## **TECHNICAL EVALUATION REPORT**

### **Duane Arnold Energy Center Extended Power Uprate Containment Analysis Audit Calculation**

**B. J. Gitnick  
Information Systems Laboratory, Inc.**

**U. S. Nuclear Regulatory Commission  
Washington, D.C. 20555**

Figure 1. DAEC Uprate Long Term Case  
Compartment Pressures vs Time

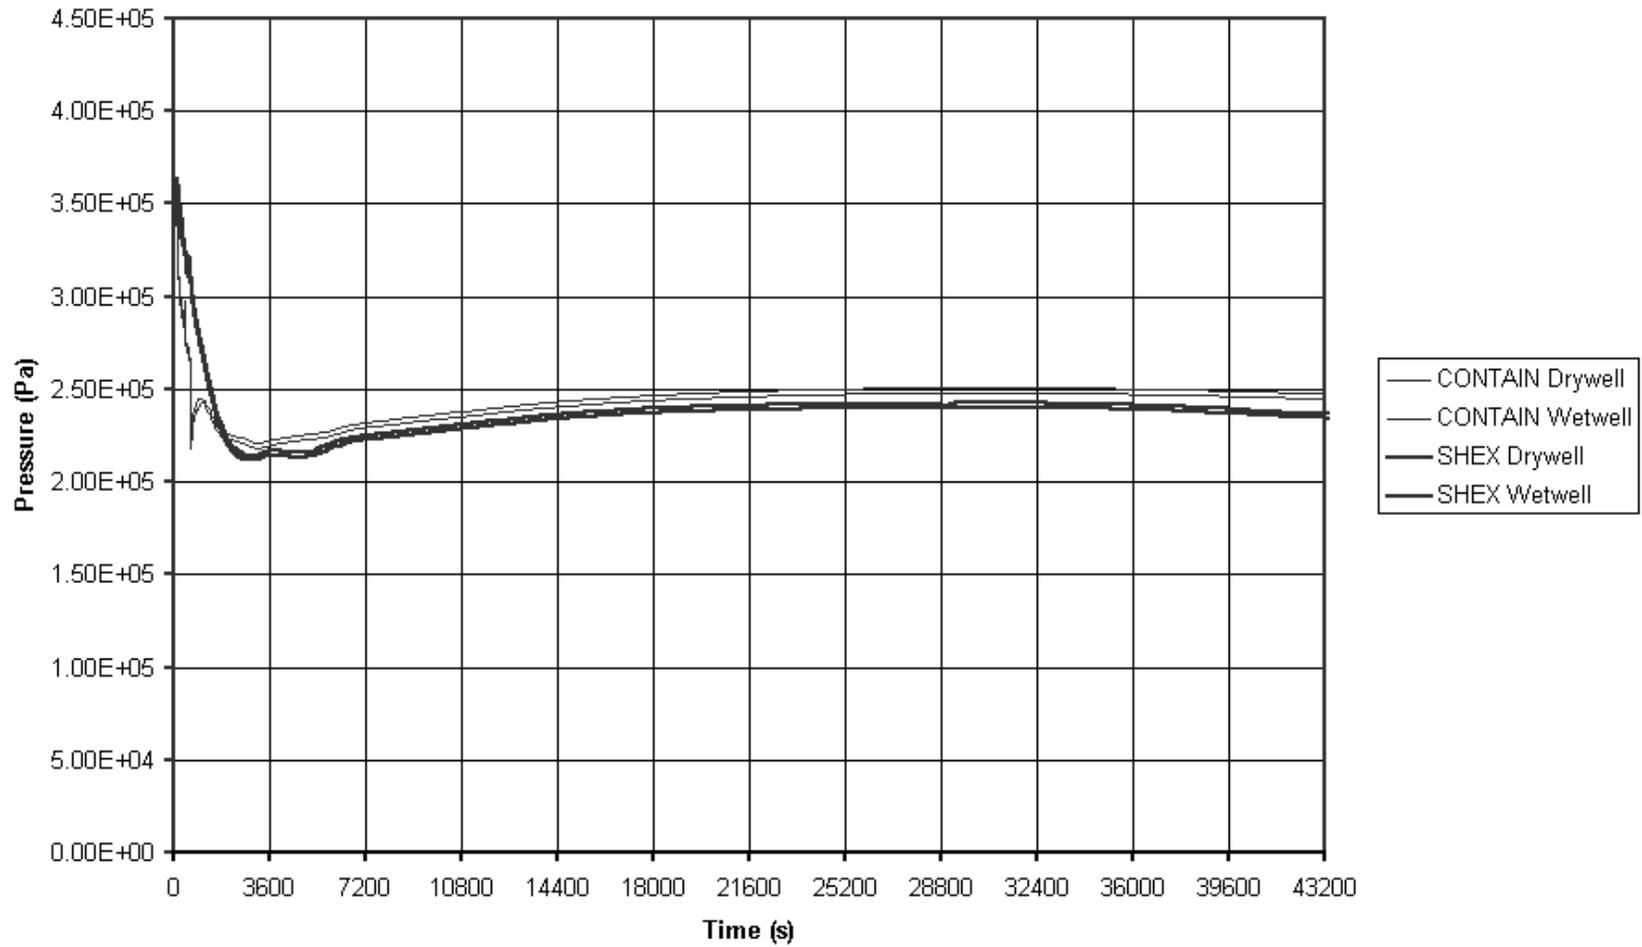
Figures 1-4 show CONTAIN results for a DBA LOCA double-ended guillotine break of a recirculation line. Figures 1 and 2 shows the long-term CONTAIN model results compared to GE's SHEX code. SHEX predicts slightly higher pressures and temperatures during the initial period, however, excellent agreement for suppression pool temperature and pressure were obtained after 40 minutes. The long-term CONTAIN calculation results in suppression pool conditions that are approximately 0.01 MPa (1.2 Psia) and 2 °K (4 °F) higher than the GE results. One exception was an apparently non-physical rise of 4-5 °K (8 °F) in the wetwell atmosphere temperature from 28800 seconds (8 hours) until 42000 seconds (11.7 hours) in the SHEX results. When questioned by the staff, GE responded that the anomalous behavior was this result of an inappropriate convergence parameter in the SHEX code. GE further stated that the improper setting of this convergence parameter did not impact the suppression pool temperature, which was the critical result for this calculation.

Sensitivity studies have also shown that the initial discrepancy in pressures and temperatures for the long-term case can mainly be ascribed to differences in modeling of mist/droplet retention in the drywell atmosphere. A portion of the small disagreement in long-term suppression pool pressures and temperatures can also be attributed to interpolation inaccuracies resulting from input of mass and energy data in CONTAIN as a linear multi-segment table.

Figure 3. DAEC Uprate Short Term Results  
Compartment Pressures vs Time

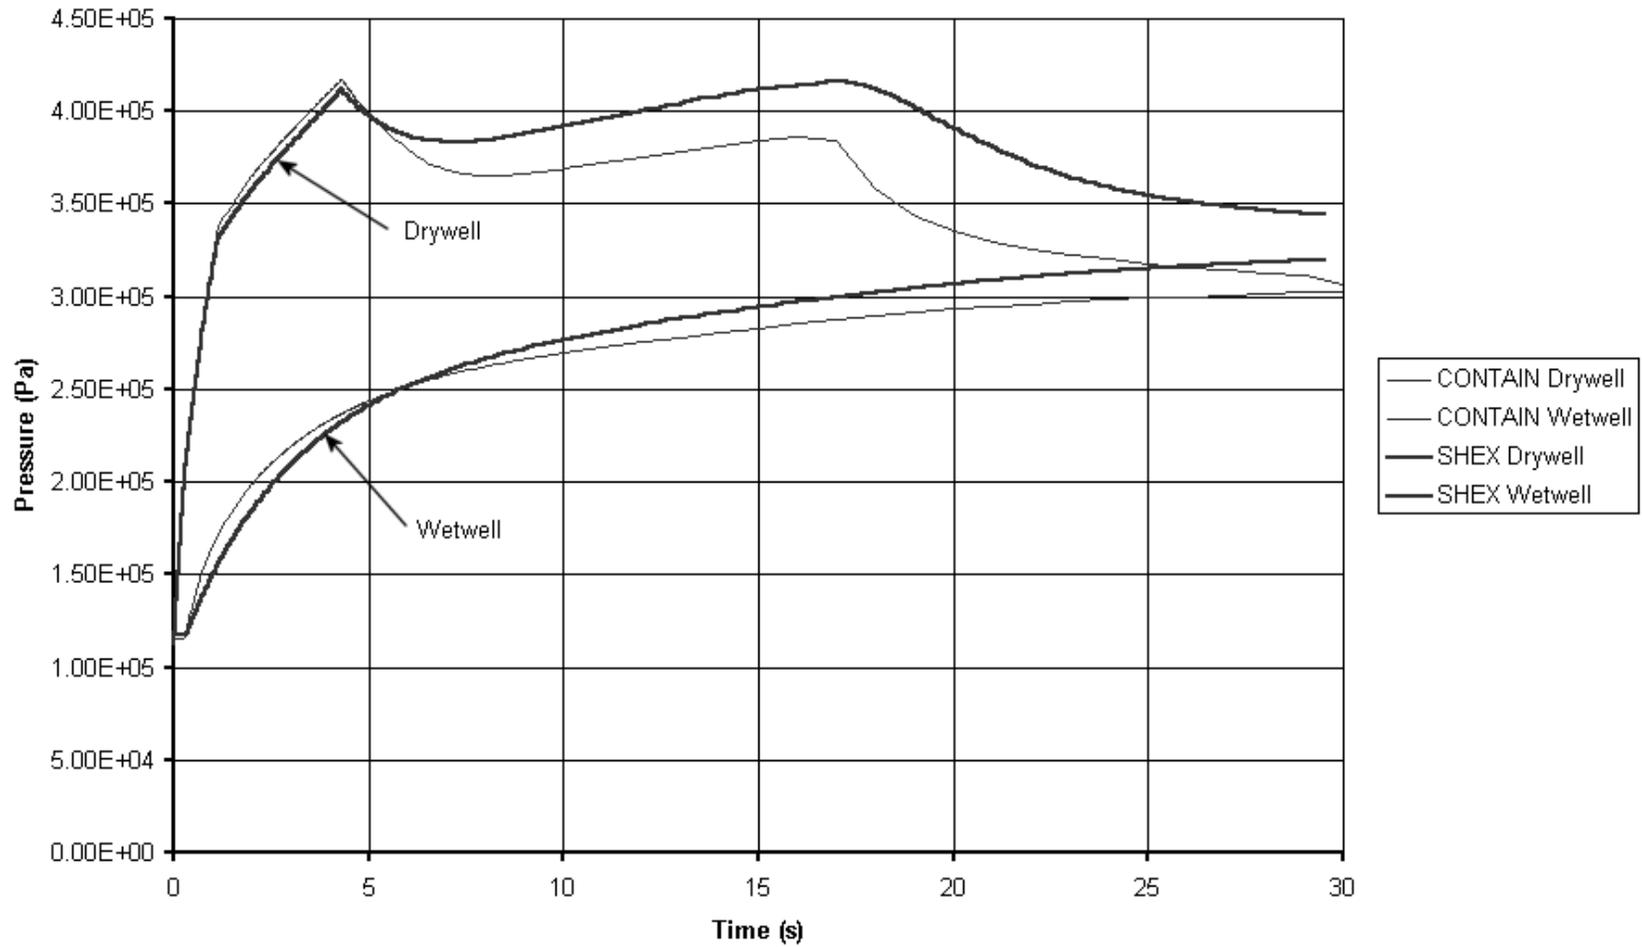
Figures 3 and 4 show short-term (0-30 seconds) results calculated with the CONTAIN short-term model compared to GE's M3CPT code. The short-term containment model differed from the long-term model in three ways:

- Different mass and energy release data were used.
- The initial vent submergence was changed to reflect the highest allowable suppression pool level (the long term model assumes that the suppression pool is at the lowest allowable level).
- Droplet parameters were changed to retain atmospheric liquid indefinitely (effectively the opposite of the “dropout” option).
